Addendum No.: 4

Date of Addendum: May 4, 2020

Prudence Crandall Museum Renovations  
1 South Canterbury Road  
Canterbury, CT  
BI – RR – 28

GAD no. S-101 First Floor Framing Plan project no. BR-RR-28

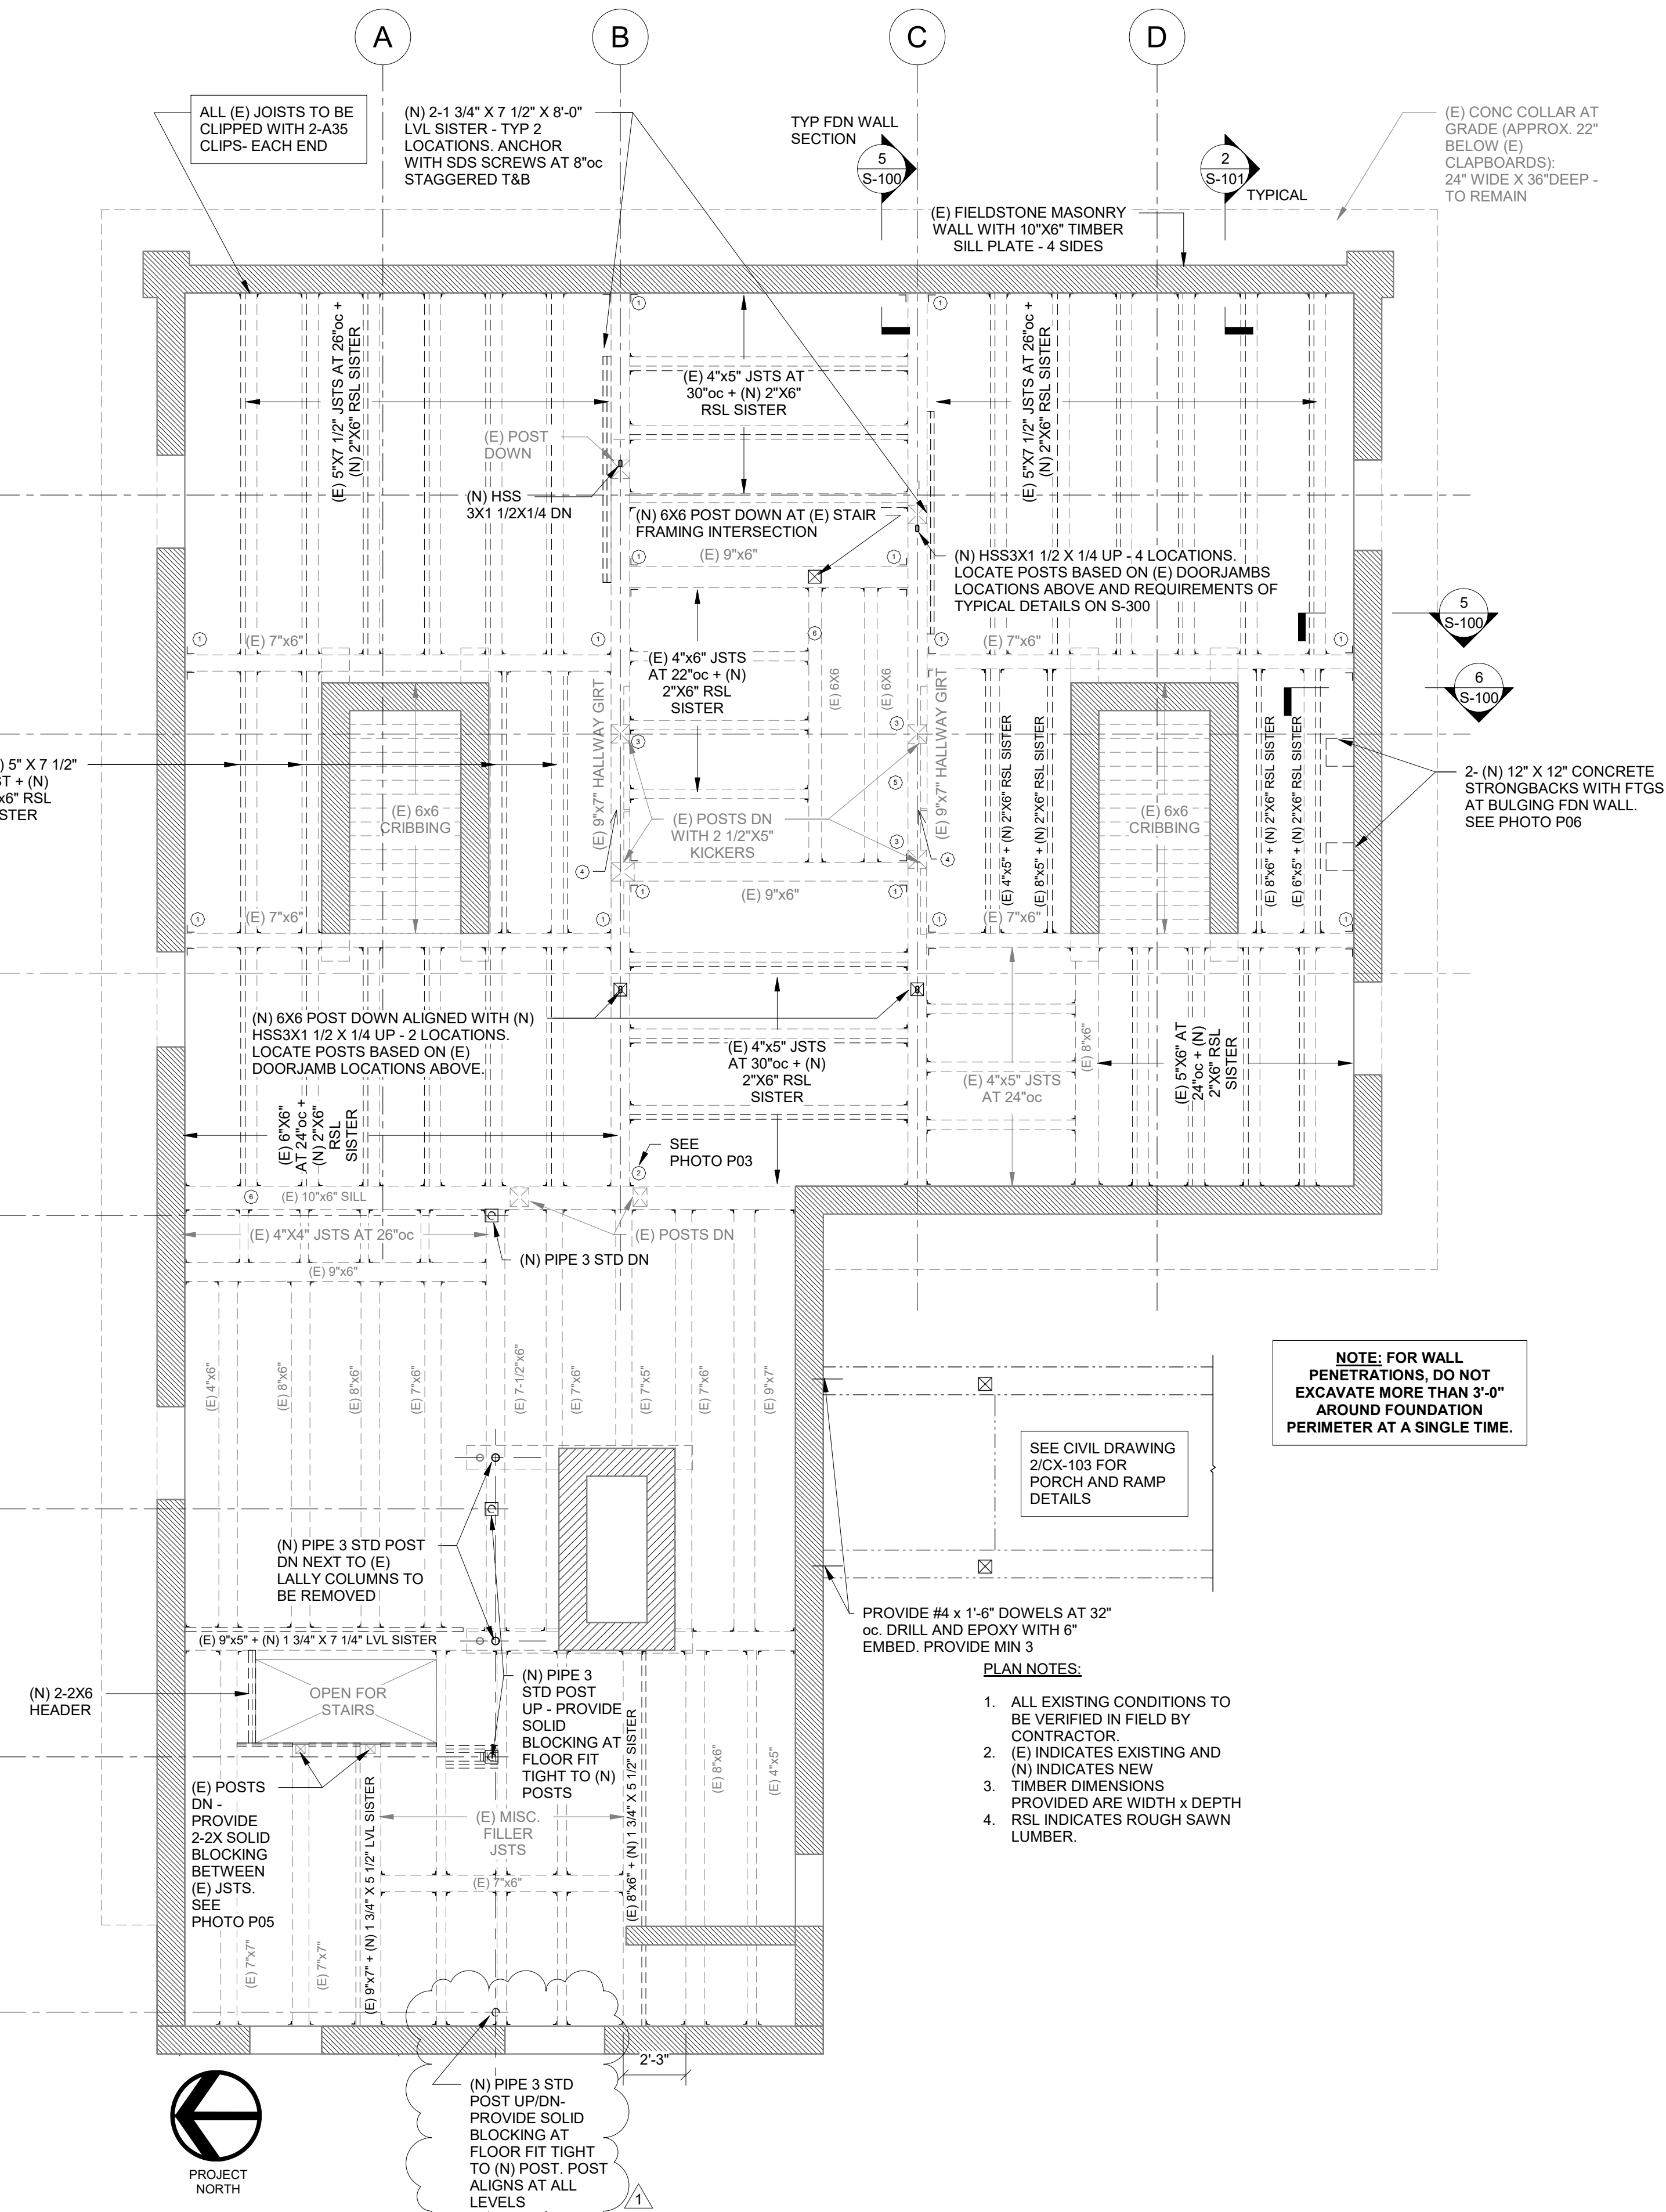
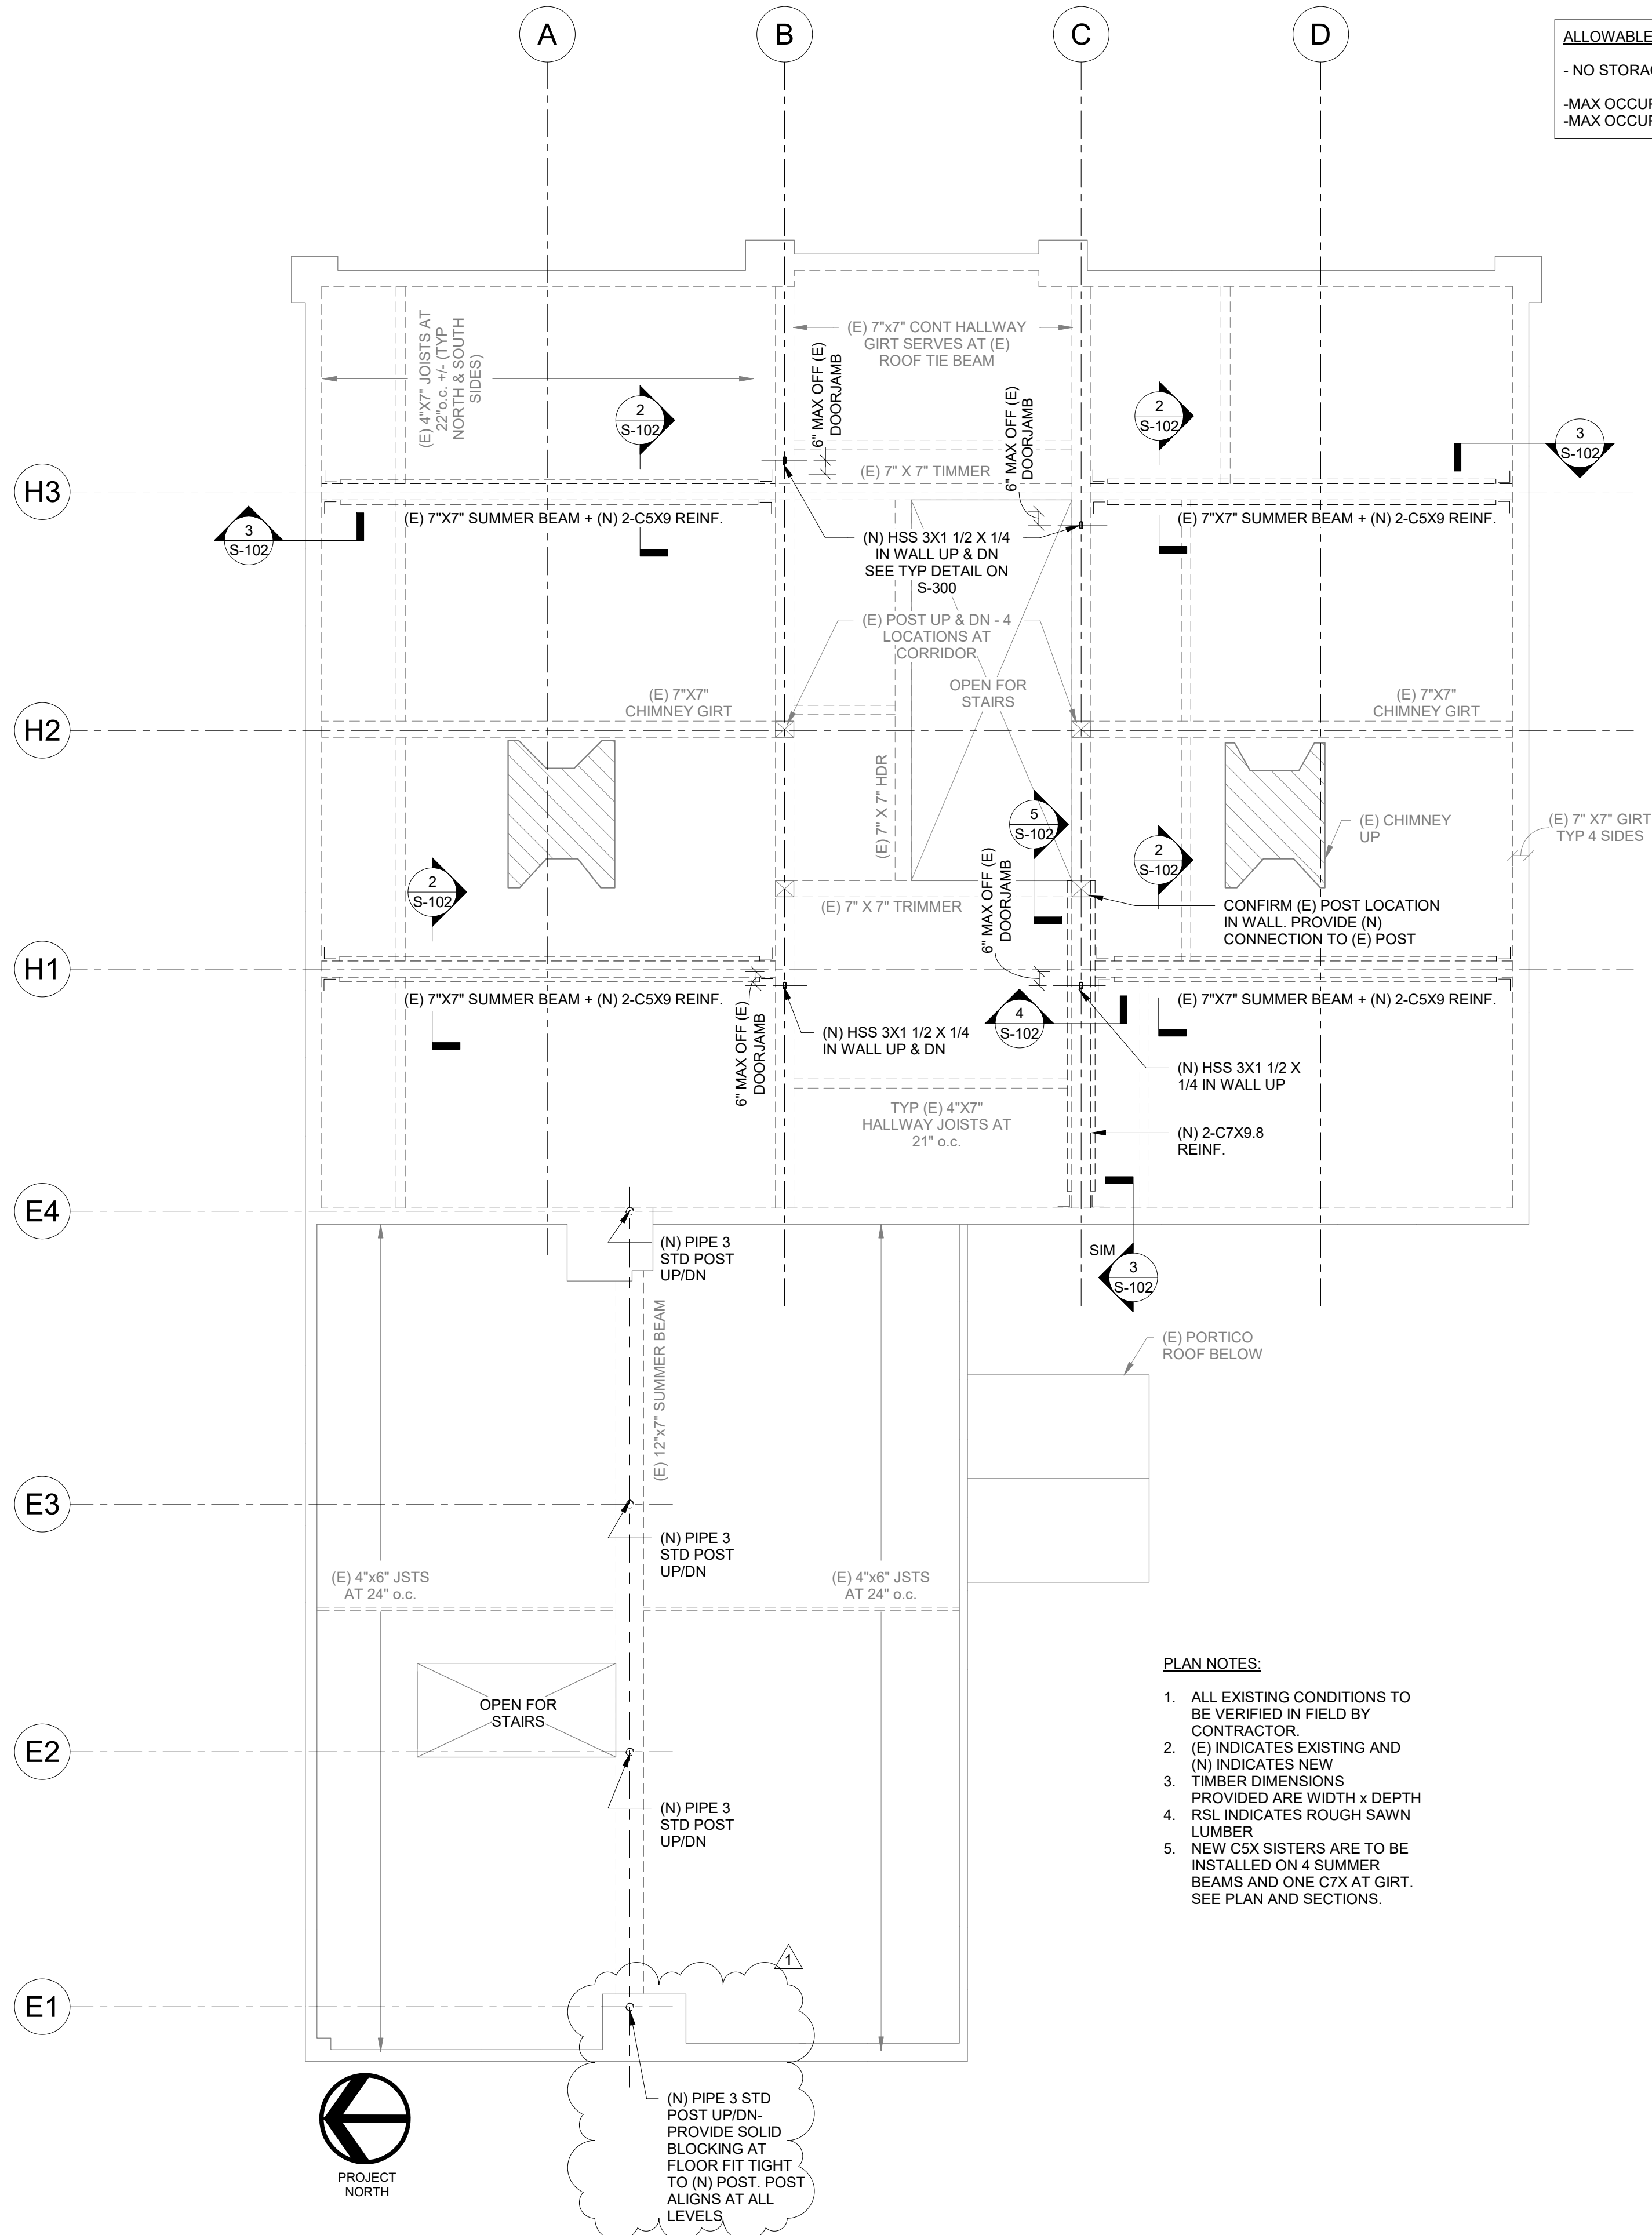
**Question 3:** *Drawing S-102 calls for a 3" pipe down at gridline E1. Drawing S-101 does not show a 3" pipe at E1. Drawing S-103 shows a representation of a pipe at E-1 with no call out. Please clarify if this pipe goes up or down, or both, or none?*

**RESPONSE:** Column should extend from ridge down to foundation. See revised structural drawings S-100, S-101, S-102, S-103, S-104, dated April 30, 2020, attached.
